Recall for Replacement: GRIGRI 2

Concerns all GRIGRI 2's (D14 20, D14 2G, D14 2B)
with the first five digits of the serial number between 10326 and 11136

Figure 1

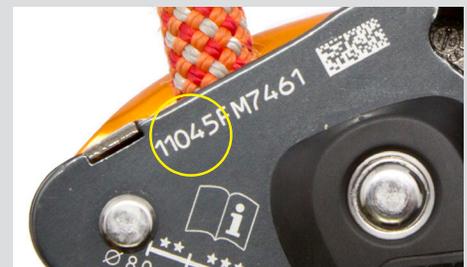
Petzl has discovered that exerting excessive force on the fully extended handle of the GRIGRI 2 can cause internal damage, such that the GRIGRI 2 handle may become stuck in the open position, as pictured in Figure 1 below.

When the handle is stuck in the position shown in Figure 1, the assisted braking function is disabled. A damaged GRIGRI 2 in this configuration will function similarly to a manual belay device (e.g. tube-style device). When using a damaged GRIGRI 2 with the handle stuck in the open position, failure to control the braking side of the rope will dramatically increase the risk of an uncontrolled descent, possibly resulting in injury or death. A GRIGRI 2 with a damaged handle must be immediately retired from service.

- Ask users to immediately stop using all GRIGRI 2's with the first five digits of the serial number between 10326 and 11136.
- **Recall all affected GRIGRI 2's and replace with new, revised versions.** Petzl will pay for all shipping costs to complete this replacement.
- Increase the mechanical strength of the handle on all GRIGRI 2's from serial number 11137 onward.
- Begin shipping replacement GRIGRI 2's immediately. Users will receive replacements in the same order they return their old units to Petzl.
